Memo

Re: Consultation on an Application

Planning Application Ref: PL/25/1263

Proposal: The extension and refurbishment of an existing Listed house. New off street parking and external landscaping.

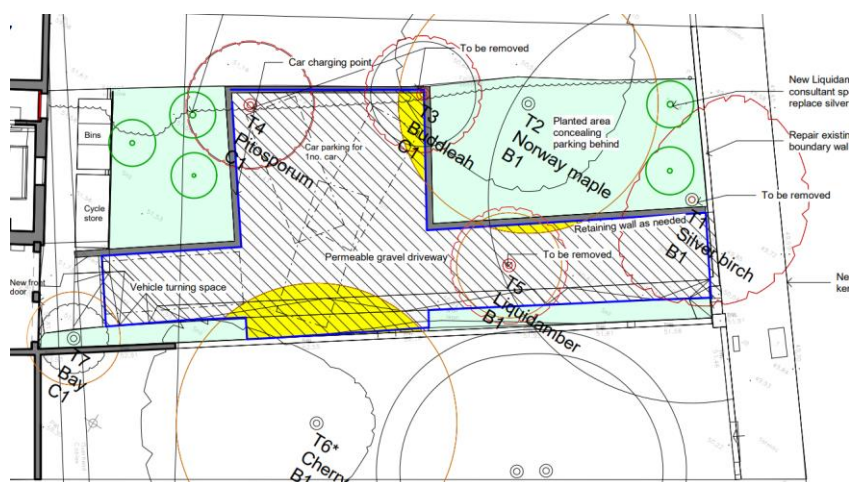
Firstly, the development will lead to the removal of one shrub and four of the trees on the frontage, including the Silver Birch tree which is protected by a TPO. This is an extremely negative aspect of the proposal. Whilst replanting has been proposed, the amenity value of the Silver Birch is not simply replaced by replanting. It is a 'B' category, mature tree which contributes to the street scene, 'treed corridor' and canopy cover of the Borough. Replacing an established, mature tree with young, newly planted trees which are of a lesser size, will result in a loss of amenity value and negative impact to the street scene for many years. The Silver Birch tree in particular is worthy of a TPO - it is unclear if the applicant has undertaken an exercise, with arb input, to see if the tree could feasibly be retained whilst allowing some parking.

The AIA has not provided a Tree Constraints Plan or a Tree Protection Plan. I am unclear why neither of these have been provided as retained trees must be protected from development related harm. The AIA refers to appended plans however they have not been submitted alongside the report and are required. The survey has identified trees adjacent to the site, and the front garden landscape plan clearly shows impacted RPAs. Working methodology within the RPA of these trees is vague and does not mention any reference to retaining roots.

6.10 states '*All new pathways and soft landscaping areas within the Root Protection Areas (RPAs) of the retained trees should be designed using no-dig, up and over construction and in close co-ordination with the retained Arboriculturalist using porous materials.*' 6.7 states '*There is a small encroachment into the RPAs of T2 (7%) and T6 (11%); these are assessed to be within acceptable levels as these are healthy trees which will tolerate this small amount of root loss and recover quickly, especially when considering there are large areas of open ground to the other side of the RPAs for compensatory root growth to develop.*' It is not agreed this is an acceptable approach when working in the RPA of retained trees. The consultant has effectively suggested that all roots within the impacted RPA can be severed, which would imply that there will be

excavation and thus the reference to 'no dig' construction is irrelevant to the works in the front garden. When there is incursion into the RPA, and root severance is proposed, it is expected that this impact is mitigated through offsetting the incursion elsewhere and improving the remaining root environment. However, improvements to the remaining rooting environment have not been suggested and may not be feasible given the tree is in adjacent land. Efforts should be made to retain tree roots, as simply severing all roots in impacted RPAs is not acceptable nor does it comply with the advice of the BS5837. As stated in 6.10, the proposed driveway should be designed using a 'no dig' method. Without associated plans it is, in any case, difficult to follow what is being stated.

The driveway should also be made in consideration for future root growth of the retained trees and replanted trees. This has not been suggested in the AIA, and a cellular confinement system should be used to allow for future growth as this can often lead to damage to paths and driveways, resulting in an increased pressure to remove the retained trees. The approach to the construction of the driveway needs to be reconsidered. I also advise it is reconsidered to retain the TPO'd Birch tree.

The placement of the replacement trees are in close proximity to one another, retained trees and structures, and there is not adequate space for them to reach their ultimate size. I have concerns that the retention of these replacement trees will be undesirable as future conflict between the trees, structures and driveway is likely. The three replacement trees adjacent to the dwelling are likely to obstruct light availability into the house. Seasonal nuisance such as leaf fall is often considered a maintenance burden, particularly being so close to structures and the driveway. I have concerns that the positions of the replacement trees will lead to future conflict and their retention will not be desirable. There is a limited amount of space for replanting due to the extent of the driveway.

I am concerned that the removal of the mature Silver Birch tree will set an unwelcome future precedent to remove trees subject to a TPO to facilitate development, which we do not consider acceptable nor does it comply with policy or the aims of the Tree Strategy.

The driveway will also result in a significant loss of soft landscaping on the frontage, effectively changing the character of the frontages completely, having more of an undesirable impact than that approved at No. 144.

I note the replanted trees are to be planted with the arboricultural consultants specification, however these specifications are not detailed in the AIA and thus I cannot assess whether the specification is appropriate. The species will also need to be of a

variety of species and consideration of their ultimate size and proximity to structures is necessary to avoid future conflict. I also note that the five proposed replacement trees on the frontage are of only two species (being three Himalayan Birch trees and two Liquidambar trees), for diversity purposes and resistance to pests and diseases, we expect a palette of species to be used and our preference is for native or naturalised trees.

With reference to the Proposed Rear Garden Plan including Garden Rm, 12th June 2025, Drawing. No. P106, Rev: P2, I note the following:

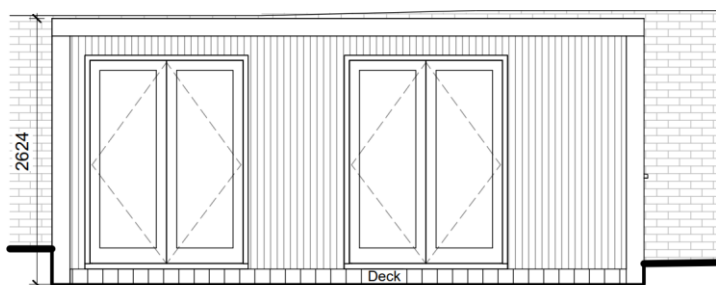
The AIA has not provided a Tree Constraints Plan or a Tree Protection Plan for the rear garden either. I am unclear why neither of these have been provided as it is common for these to be included in an AIA, and retained trees should be protected.

The rear extension requires the removal of three trees, and the outbuilding requires the removal of one, totalling the removal of an additional four trees. Due to the outbuilding and the decking leading to it from the rear of the dwelling, there is a significant reduction in soft landscaping. I question whether the outbuilding is a truly necessary component of the proposal, as this will increase the amount of hard landscaping significantly and result in further tree and soft landscaping loss. This also limits the amount of useable outside garden space. As the useable garden space will be further limited due to the replanted trees, their retention may be undesirable. If the outbuilding was omitted, there would be more space for planting to mitigate for the loss of trees and soft landscaping this development will lead to. The proximity of the replanted trees and the outbuilding is also likely to result in future conflict making their retention undesirable.

In relation to future conflict 7.1 states '*The retained trees are at a satisfactory distance from the proposed new structures and highly unlikely to give rise to any inconvenience.*' I would disagree with this given the proximity of the Beech tree and the outbuilding shown in the rear garden landscape plan. The canopy overhangs the outbuilding and thus future conflict and pressure to prune or remove the tree is likely. There is a path leading from the rear extension to the outbuilding, appearing to be made of decking which would be built above ground level and minimising excavation. However, as the tree also overhangs the decking, seasonal nuisance and future conflict is likely to make the retention of this tree undesirable also. The methodology for constructing the decking has not been described in the AIA.

6.8 of the AIA states 'A portion of the proposed new garden structure would be situated within a section of the assessed Root Protection Areas of T12 as can be seen on the appended plan'. As it does not state a percentage of incursion and no appended plans have been submitted, this incursion is difficult to appreciate and assess. The RPA is also not shown in the rear garden landscape plan. The use of 'screw pile' foundations is an acceptable foundation type within the RPA of retained trees. However, with reference to the Proposed Garden Room (undated), Drawing No. P107, it appears to be built below the existing ground level and thus requiring excavation. I am also unclear whether there is enough clearance between the ground and crown of the tree. The AIA states there is 3m of clearance from the ground to the crown of the tree, however the outbuilding is 2.62m tall if built below the existing ground level. Once placed on screw pile foundations, the finished height of the outbuilding would be closer to the crown of the tree, with less than 40cm clearance currently with reference to the Elevations. 6.3 of the AIA states 'The implementation of the proposal does not lead to the requirement to prune any of the retained trees' and 6.4 states 'The defining branch structure of this tree is however well clear of the proposed upper building line', which I would disagree with as less than 40cm clearance is not adequate. For the reasons I have stated, the outbuilding should be omitted from the application should it receive approval.

As stated for the front garden, the species choice for the replanted trees also needs to be more diverse and considerate of their ultimate size and proximity to structures.
